April 21, 2011

Re: Homewood Mountain Resort DEIS/EIR/Master Plan

1) Above, from Figure 14-4, page 14-23.

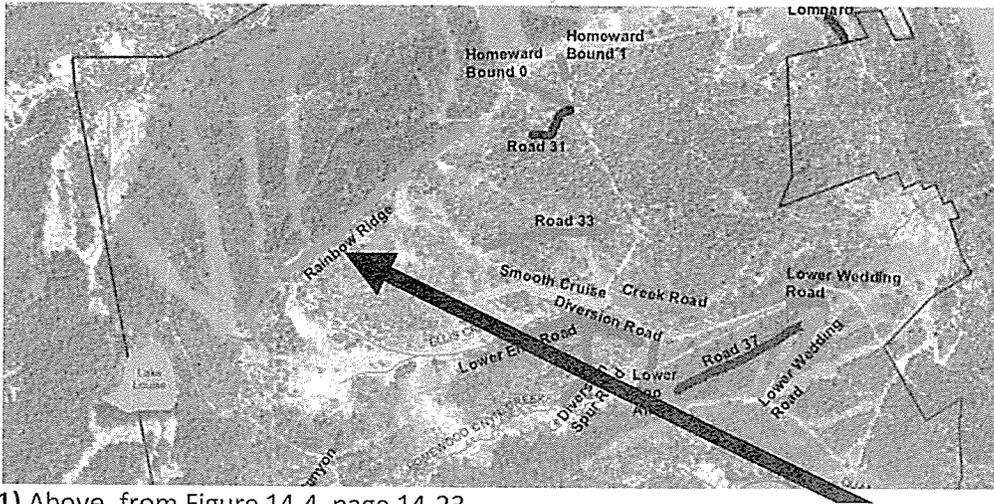
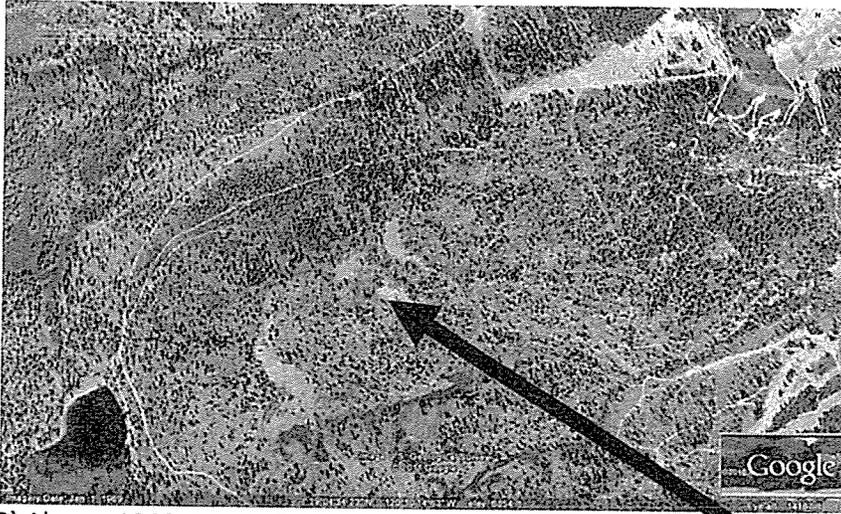
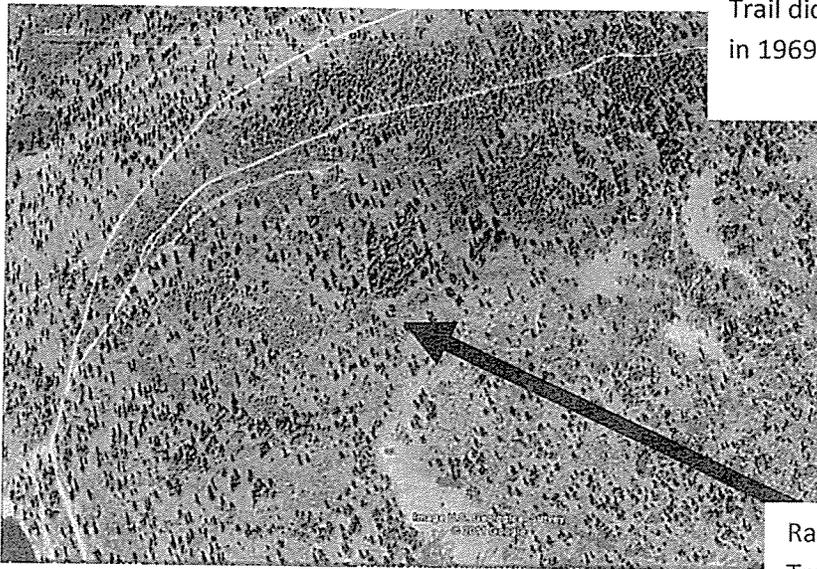
[Figure 14-4 shows that "Rainbow Ridge" was treated in 2007. What is the square footage of coverage from this area that that has been or is intended to be transferred, banked, or converted to hard coverage? How much vegetation, including trees, will be allowed to grow on "Rainbow Ridge"? Historical data from Google Earth show that this road did **not** exist in 1969. Was it created between 1969 and February 10, 1972? What evidence is there to support this? Many of the historic dirt roads do appear on the 1969 Google Earth Aerial photos, so it seems unlikely that another road would have been created during the short period between 1969 and early 1972. If it was created during that time, is there evidence to support its specific width and configuration? Below is a close-up of Rainbow Ridge 1) from Figure 14-4, 2) 2011 Google Earth Aerial, 3) 1969 Google Earth Aerial, 4) zoomed 1969 area:

Rainbow Ridge
Trail did not exist
in 1969.

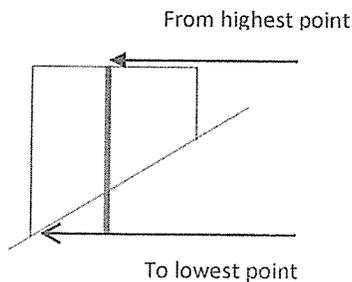
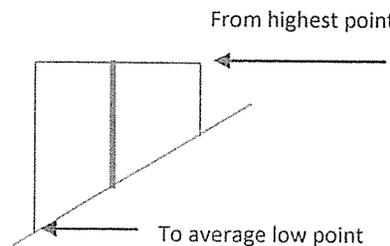
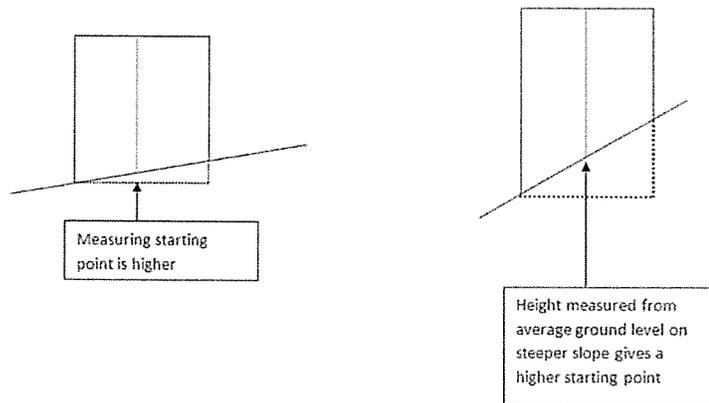
The TRPA currently measures height from the lowest natural ground elevation of the building to the highest point of the building. The Code states:

It is clear that the proposed method of measurement would allow taller buildings. In addition the proposed method of measurement would also provide an incentive to build on slopes because this method of measurement allows taller and more massive buildings. The proposed method of measurement also provides incentive to build up steeper slopes, as well, because with a steeper slope, the starting point of measurement would be higher, as illustrated below:

The TRPA code of ordinances method of measuring height attempts to protect mountain and lake views from intrusively tall buildings. The DEIS states that changing the method of measurement to allow for 77 foot high buildings will not impact scenic resources and states, "The height amendment, if approved, will allow building heights up to 77 feet as currently measured using TRPA Code Chapter 22 height measurement methods" (10-29). The proposed method of measuring height would allow taller and more voluminous buildings than currently allowed. The DEIS states:

Figure 10-14 Height Calculation Examples

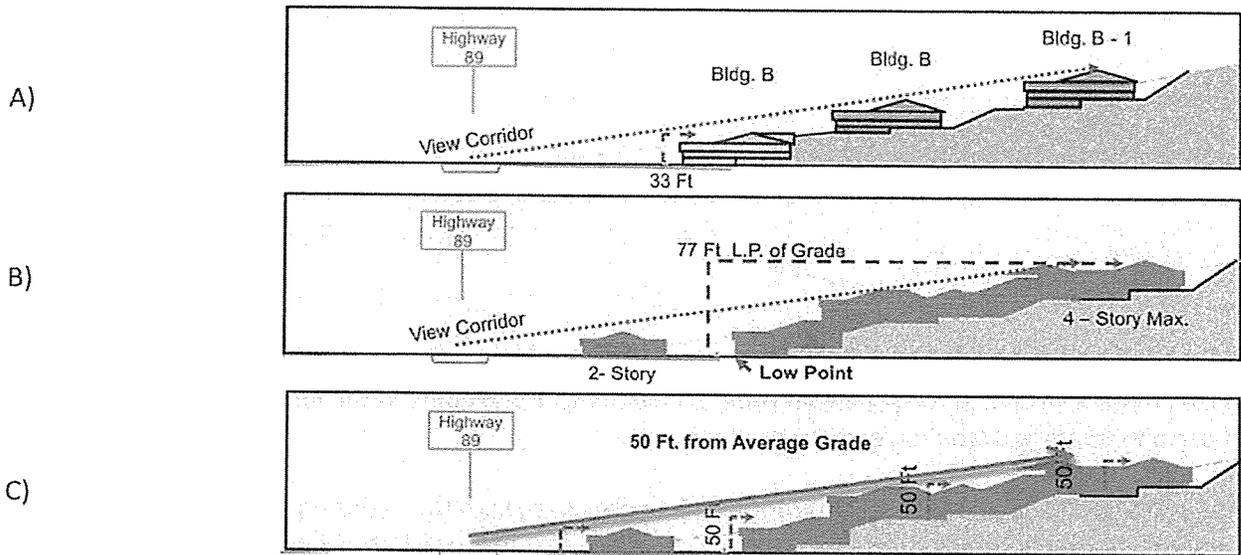
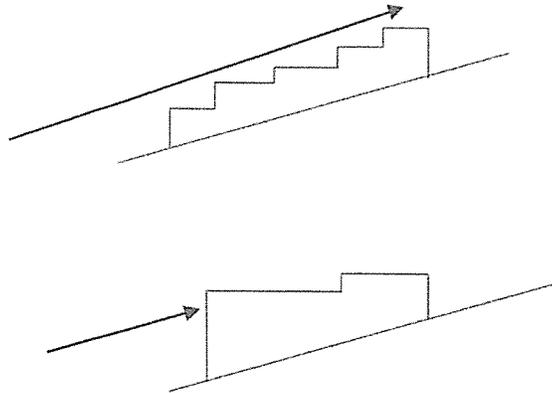
Figure 10-14 is misleading because the DEIS's rationale is that A) would create a larger footprint; this is not reflected in the figure, but rather B) and C) show larger footprints. If the entire footprint from B) had to fit along the slope in A), then the buildings would extend much further up the slope. How much additional coverage would this configuration require? Considering the land capability, amount and type of coverage, would this configuration be allowed under current regulations? Would this configuration affect scenic resources? Would buildings extended further up the slope be seen from the Lake? The DEIS asserts that the front view would be the same, whether the building is continuous or broken up, but does not discuss scenic impacts from the side-view. From the side, a continuous building up a slope may block more of the view than buildings separated with space. Secondly, C) shows the "average" bottom elevation at random places within the building, rather than the middle. There are three starting points to measure height shown in C). Figure 10-14 shows that the view corridor from the bottom to the top of the slope would be the same under the proposed height code amendment, because it shows the building stepping up the slope. The proposed code amendment outlined in Appendix F of the DEIS, states that, "buildings shall be designed to step up the slope" (page 2). "Stepping up a slope" could mean multiple configurations that would allow excess height. For example, both of the following drawings of buildings show that they "step up a slope".

The view is affected by the height of each step up the slope as well as the number of steps up the slope, which is not specified in the proposed code amendment. The second figure, above, obviously allows for more bulk/mass and would create more scenic impact.

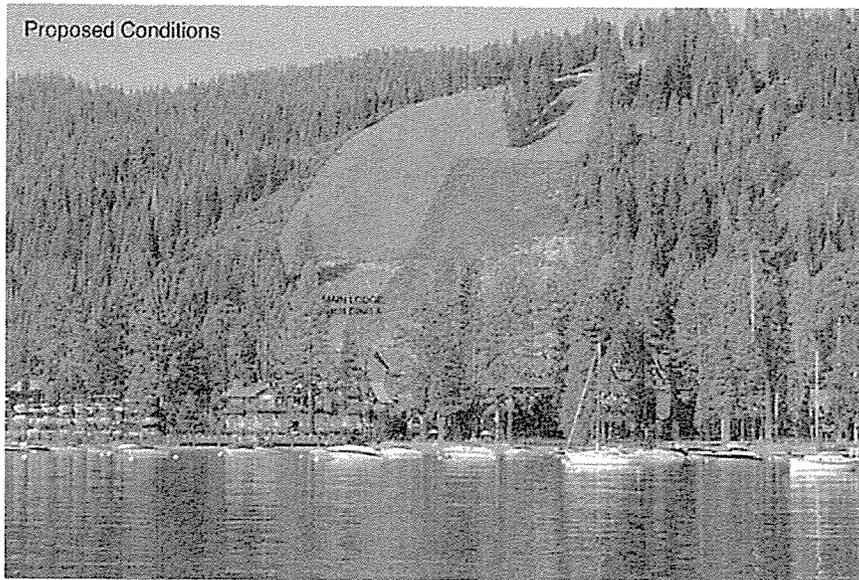
The DEIS also shows the proposed buildings almost completely blending in with the trees on page 10-14, which does not realistically represent the scenic impacts that the buildings will have because it is unlikely that the buildings' color will be perfectly camouflaged to the variation in color of the trees and the hillside. For a large portion of the year, the slope behind the building will be white, which would contrast sharply to the building. Winter simulations are only shown from a vantage point far out into the lake, rather than closer to the development.

The visual simulations do not appear to take account of the number of trees removed because both the before and after conditions show the same trees. Trees replanted after construction would not be the same height as the full grown trees that are currently at the site now. Page 8-55 reveals that at least 195 trees will be removed for the proposed development project. A tree removal protection plan is not included in the DEIS. Figure 10-6 demonstrates some of these problems with the scenic analysis:
